Addendum No. 3**Commerce Way Reconstruction
Bid #66-15
City of Portsmouth****Issued May 14, 2015**

This Addendum forms part of the original documents marked: **Bid #66-15 Commerce Way Reconstruction**. Acknowledge receipt of the Addendum within your bid proposal. Failure to acknowledge receipt of the Addendum may subject the Bidder to disqualification.

Drawing Changes**Item 3-4 Drawing R-3A– Roadway Plan and Profile**

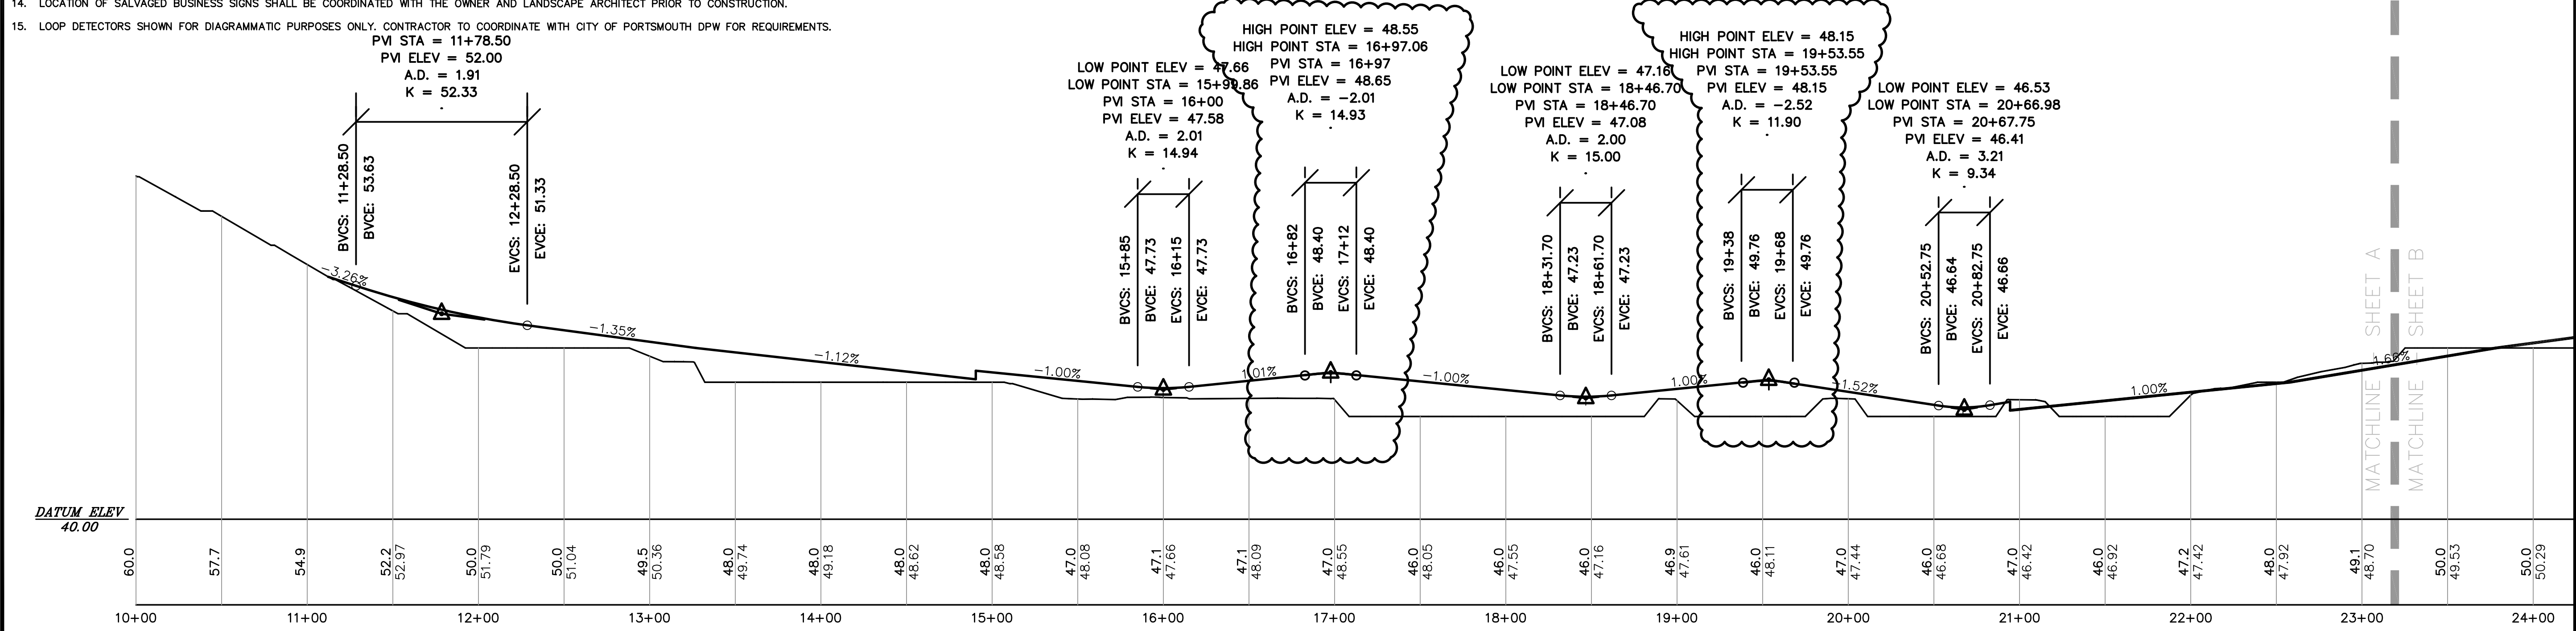
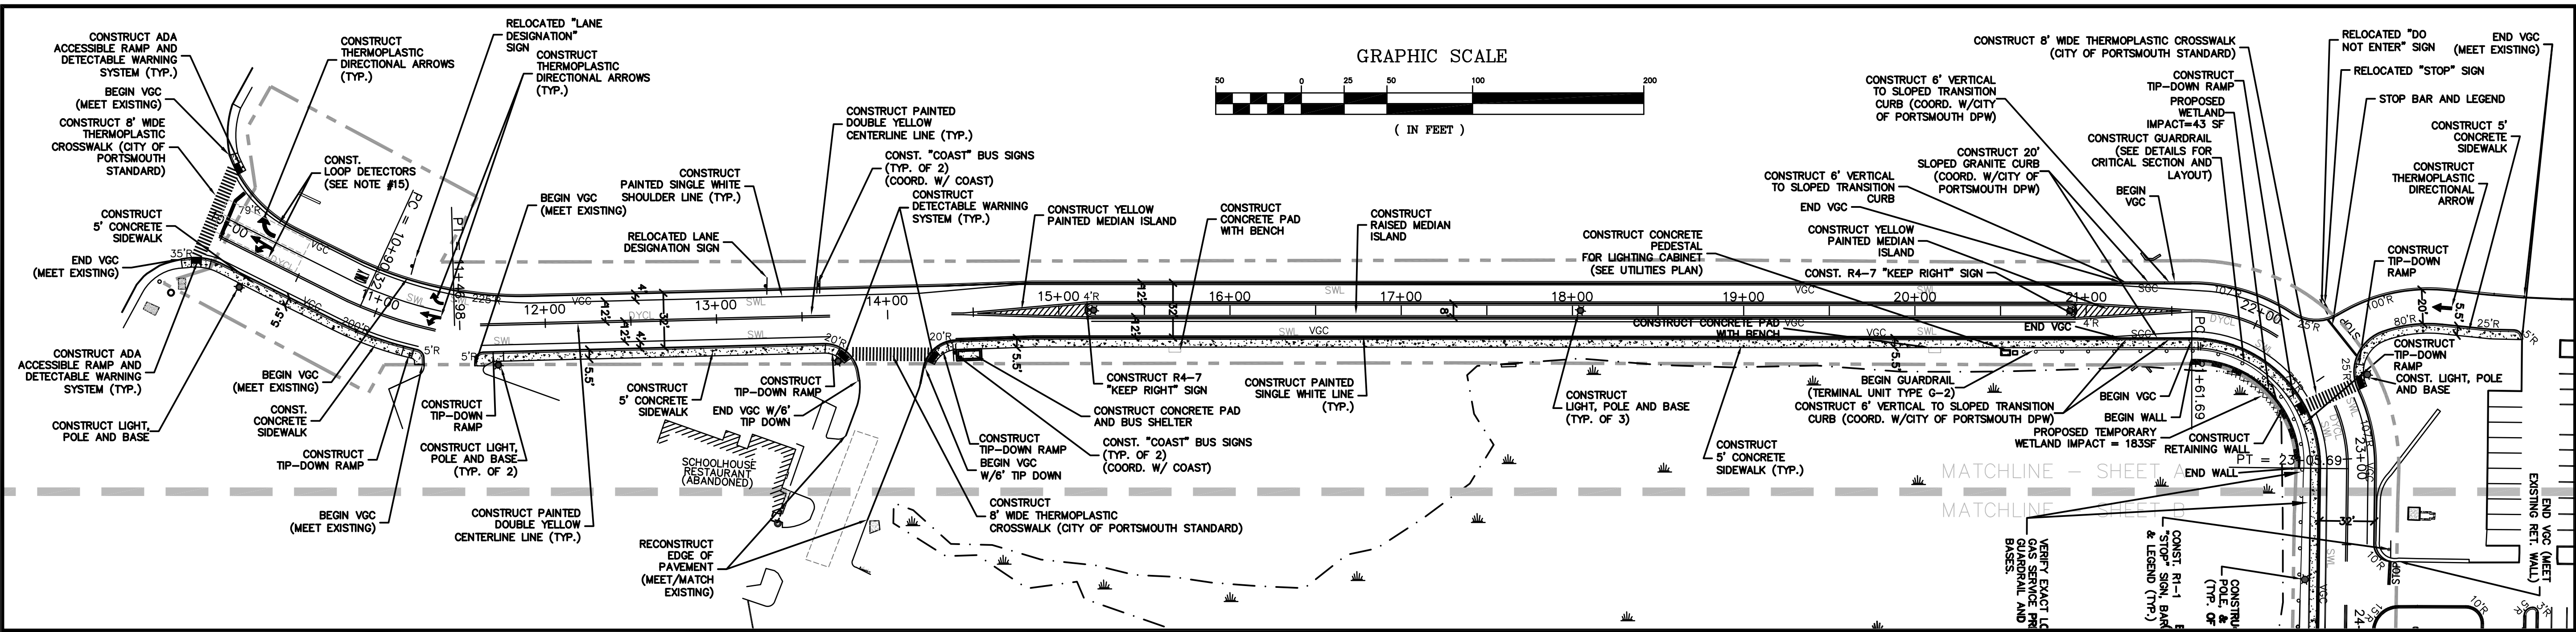
Delete Sheet R-3A in its entirety and **replace** with the revised sheet issued with this Addendum. Missing vertical curve geometry has been added to the roadway profile. Revisions to the plan have been clouded.

Item 3-5 Drawing R-5A– Utilities Plan

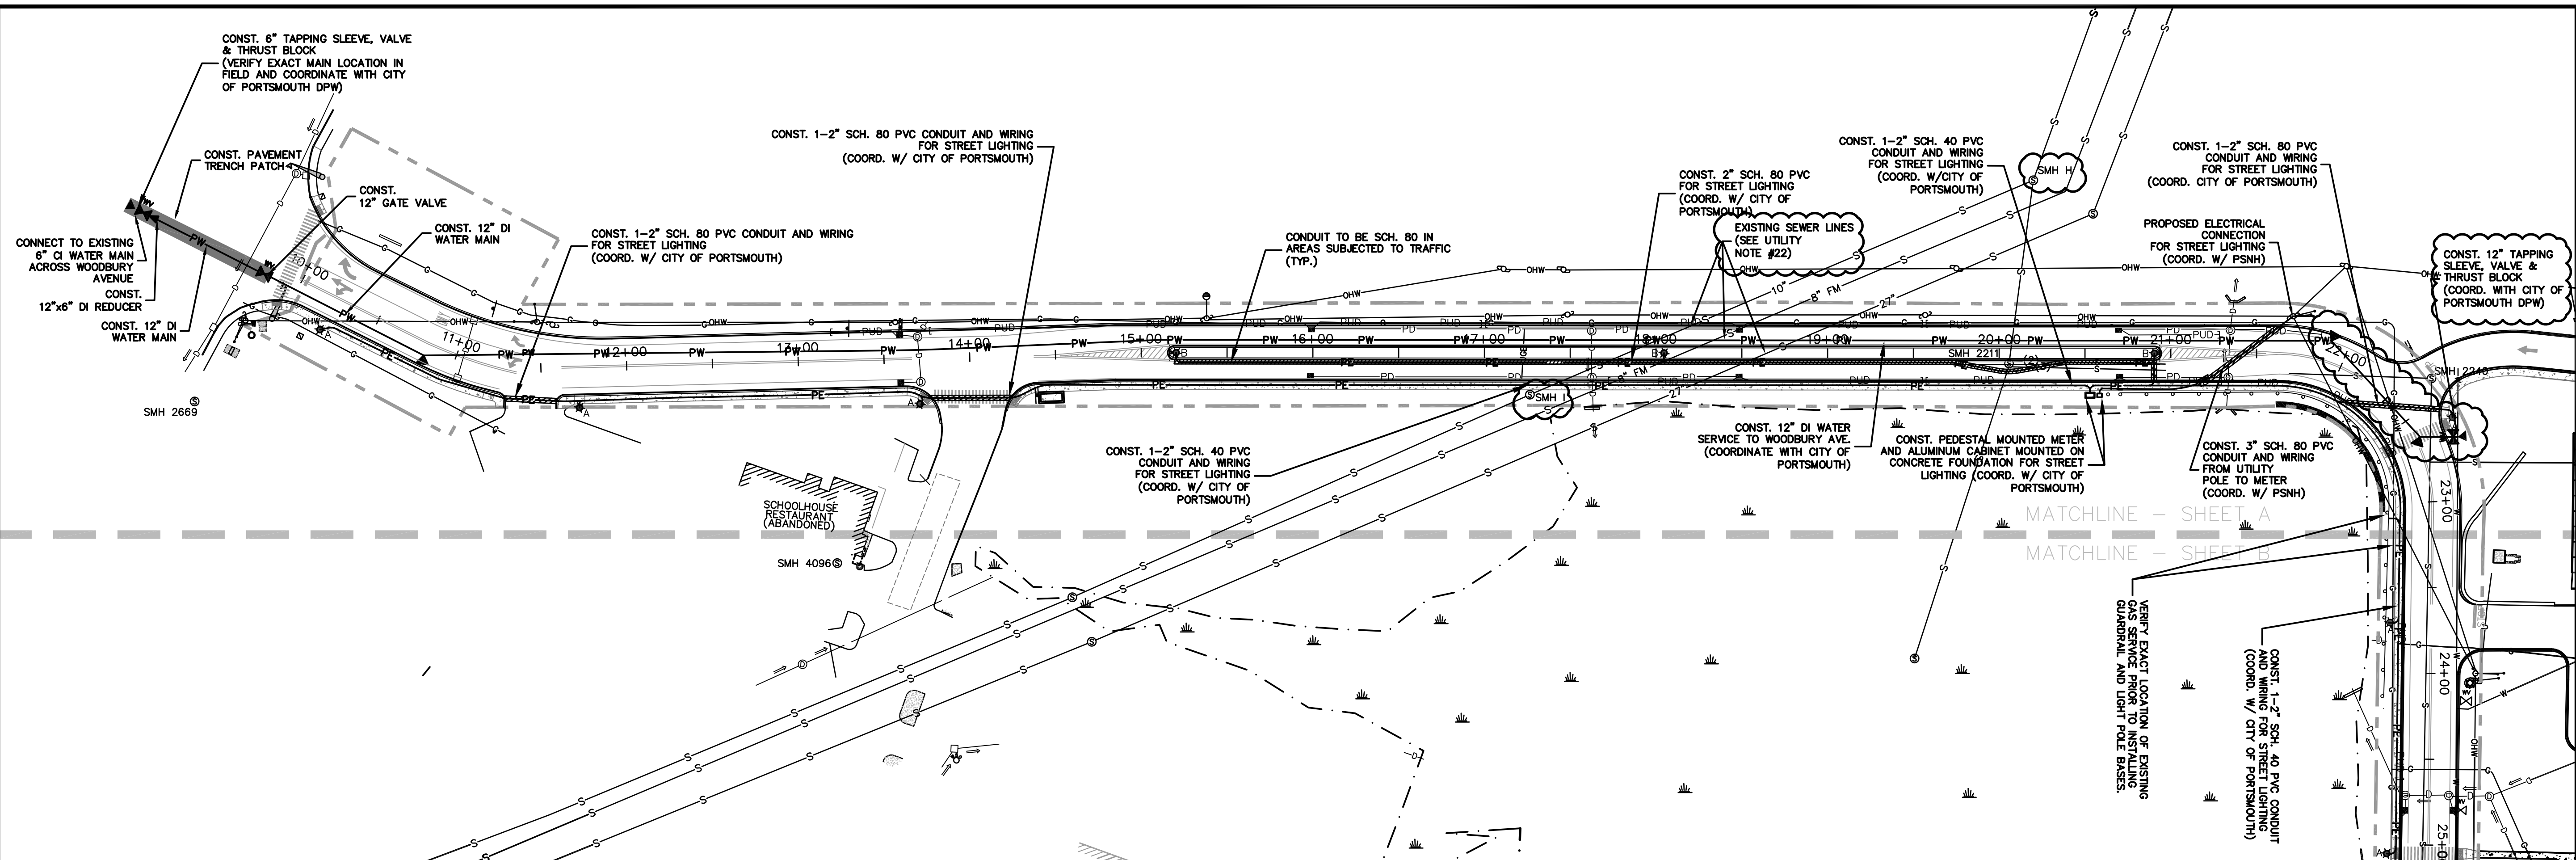
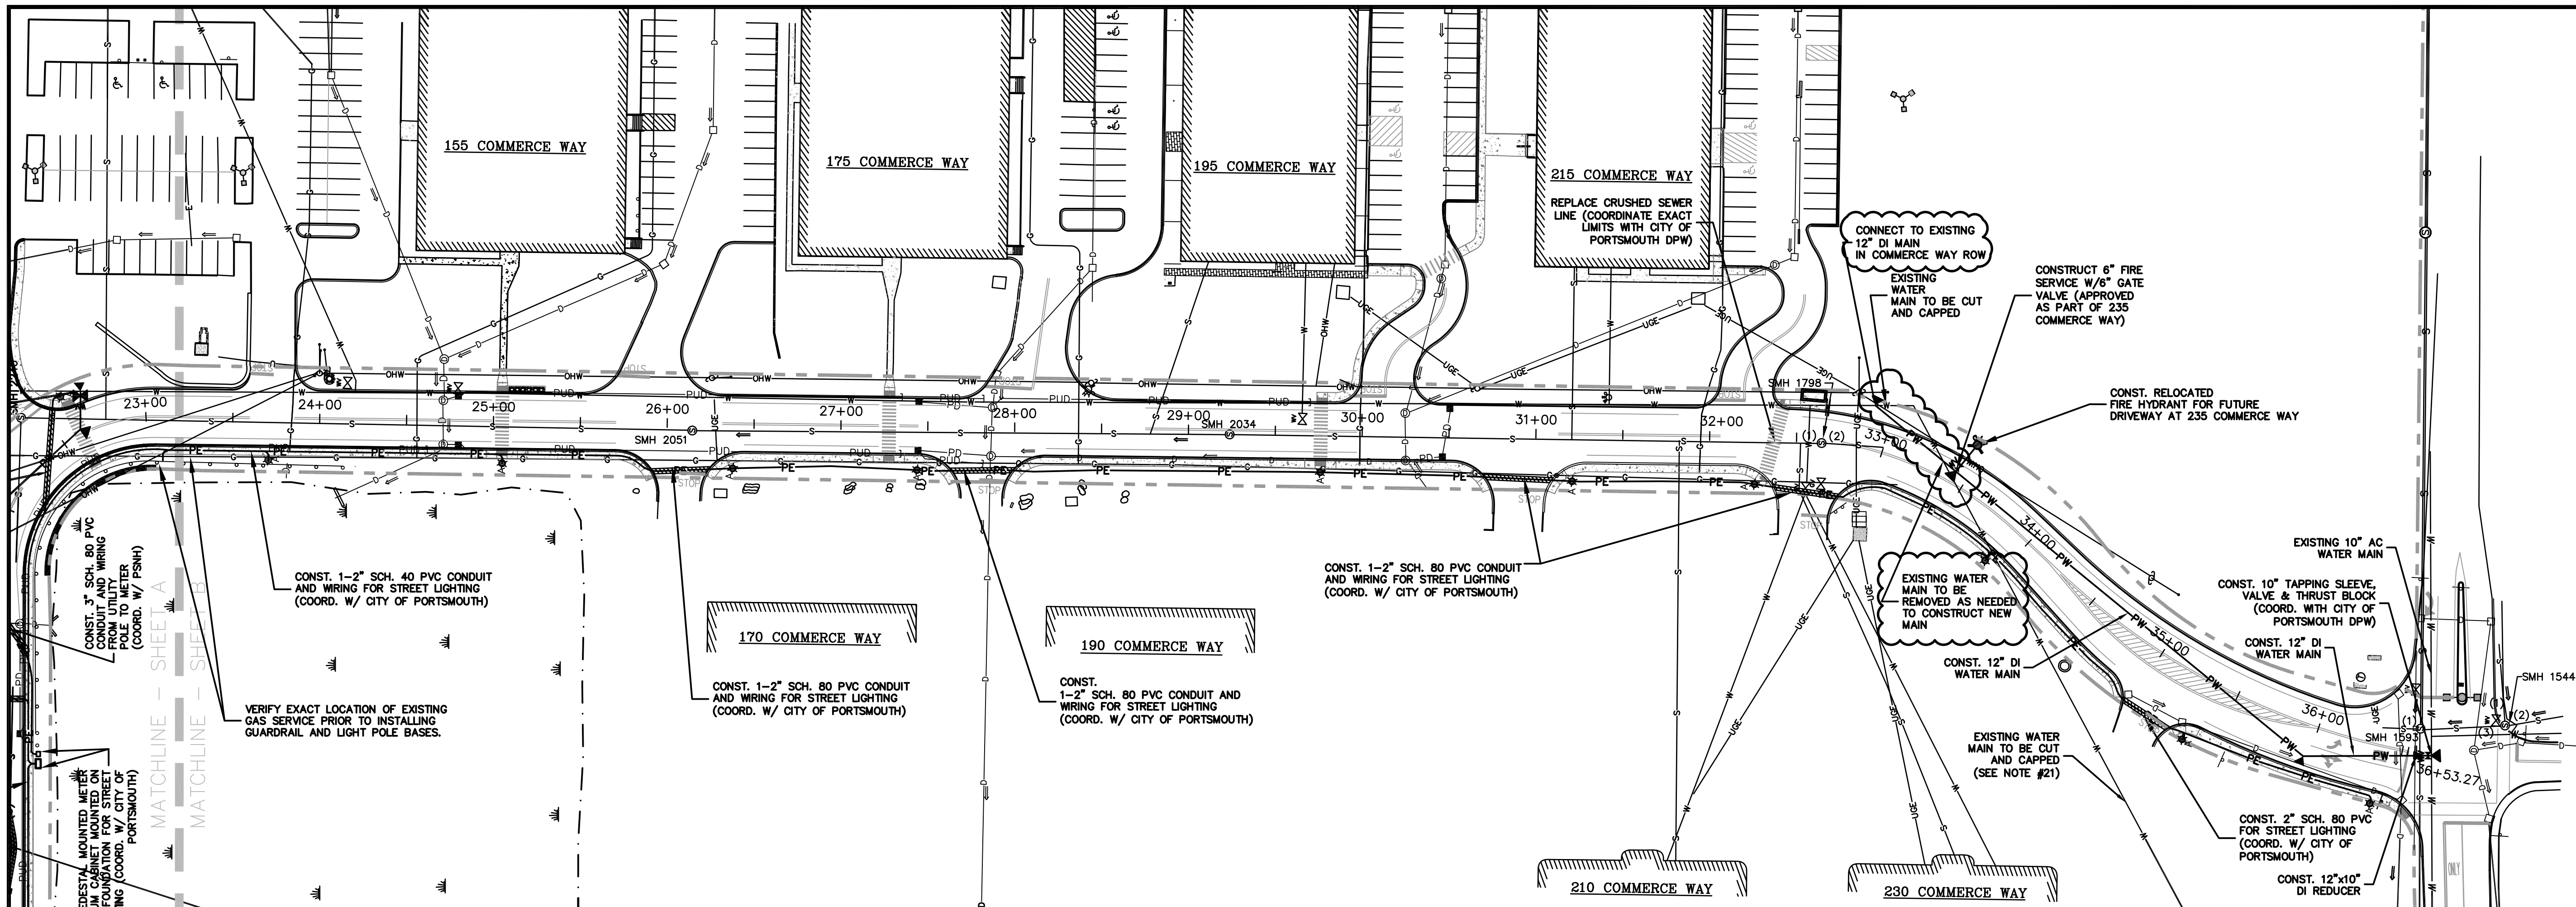
Delete Sheet R-5A in its entirety and **replace** with the revised sheet issued with this Addendum. Please note the location of (3) existing sewer mains running beneath Commerce Way have been added to the plans along with Utility Note #23. The location of the connection to the existing 12" water main in Commerce Way has been revised. Revisions to the plan have been clouded.

R-5B

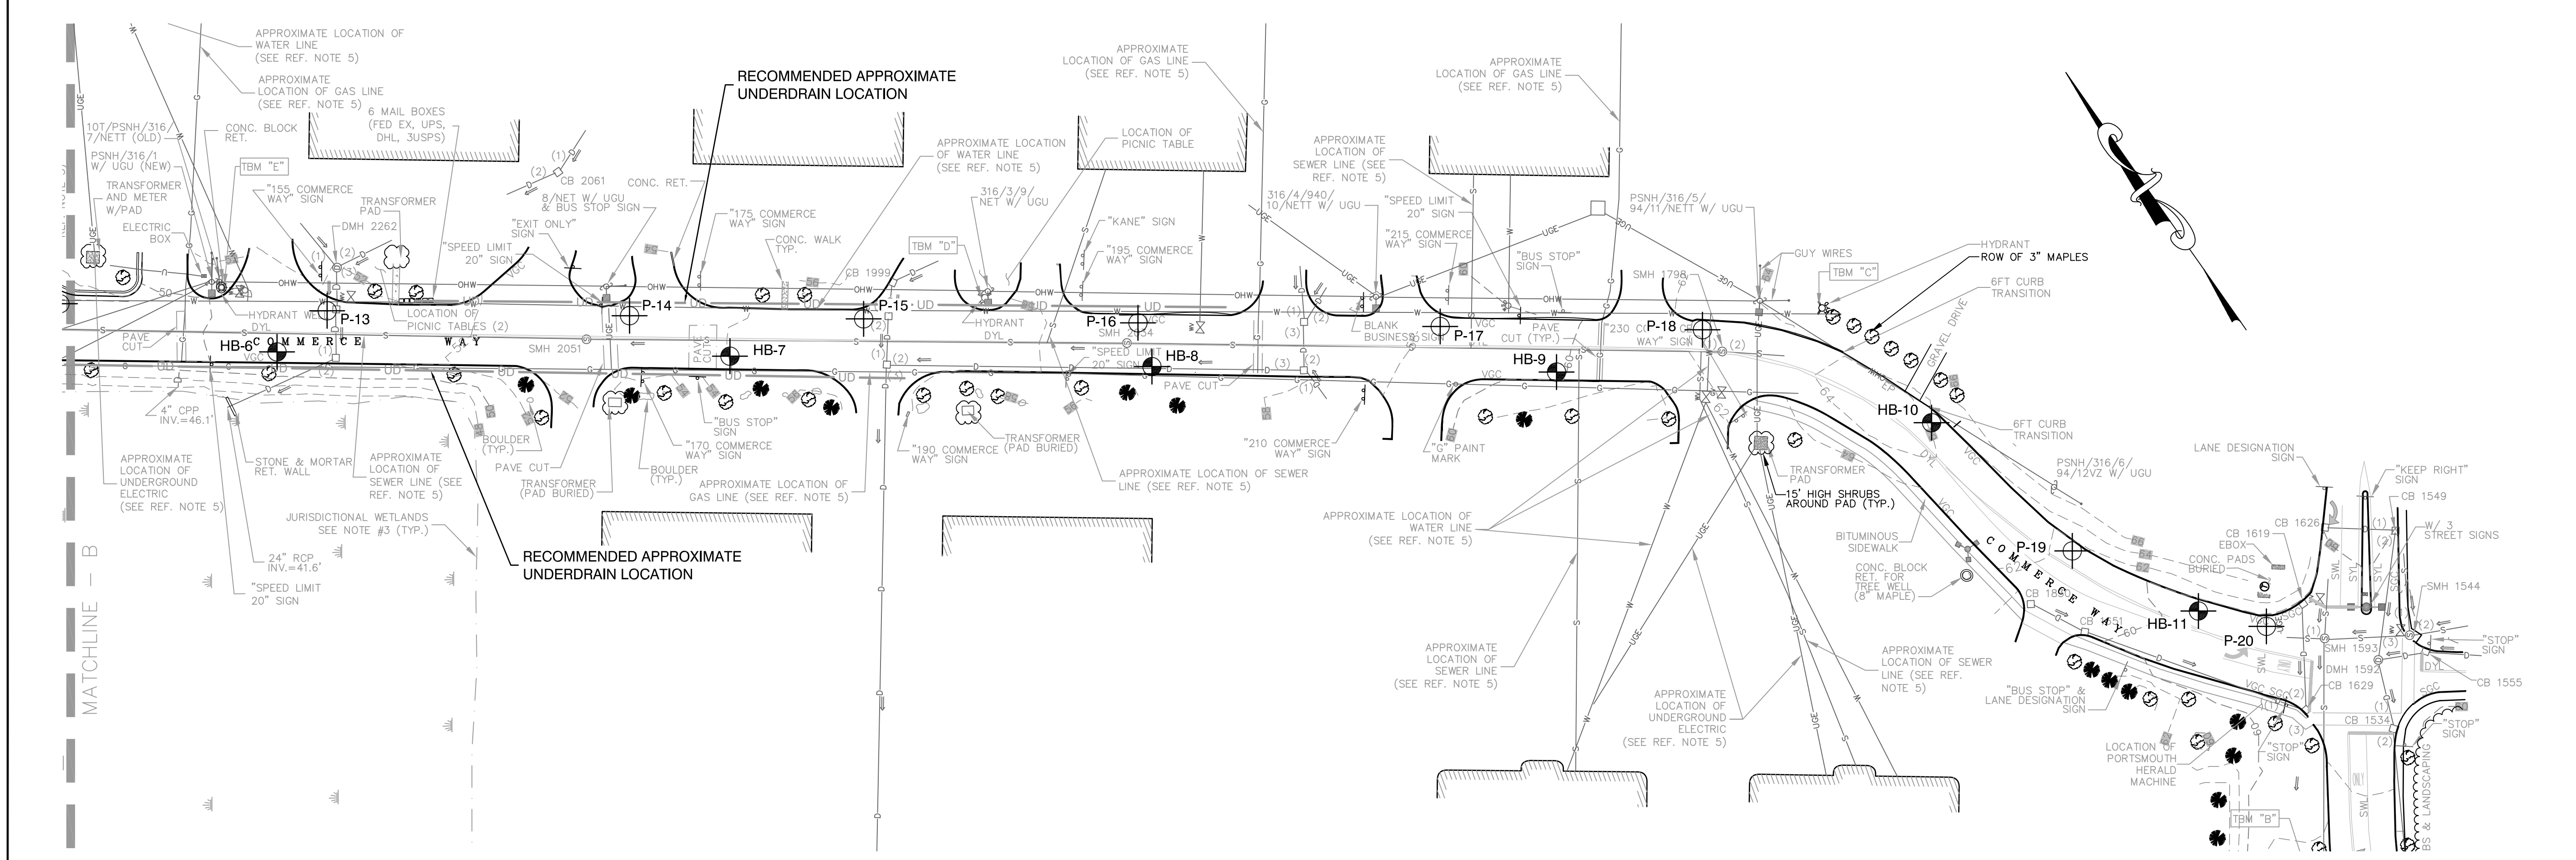
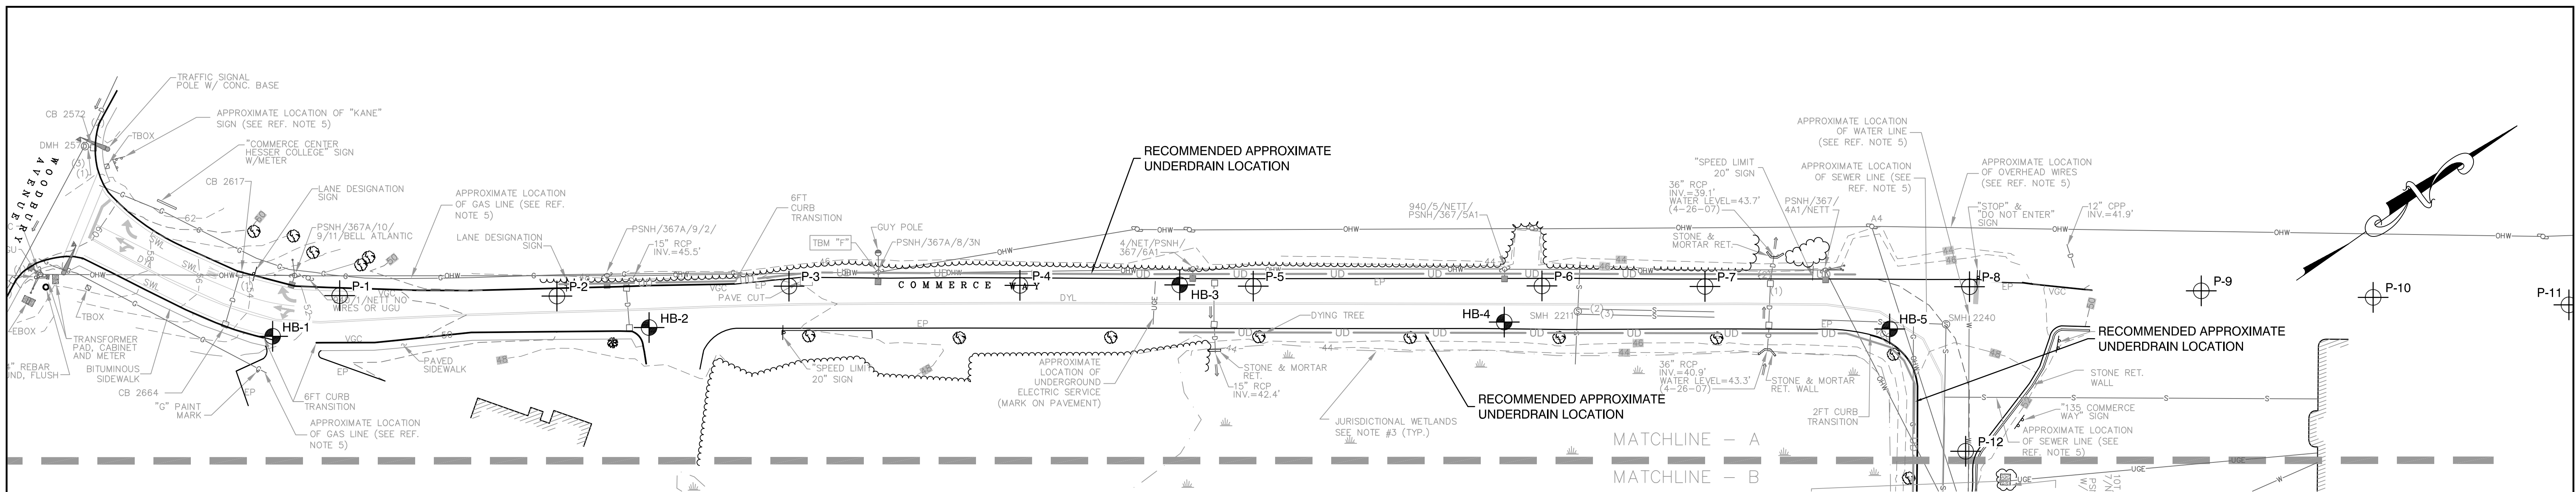
Delete Sheet R-5B in its entirety and **replace** with the revised sheet issued with this Addendum. The location of the connection to the existing 12" water main in Commerce Way has been revised. Revisions to the plan have been clouded.
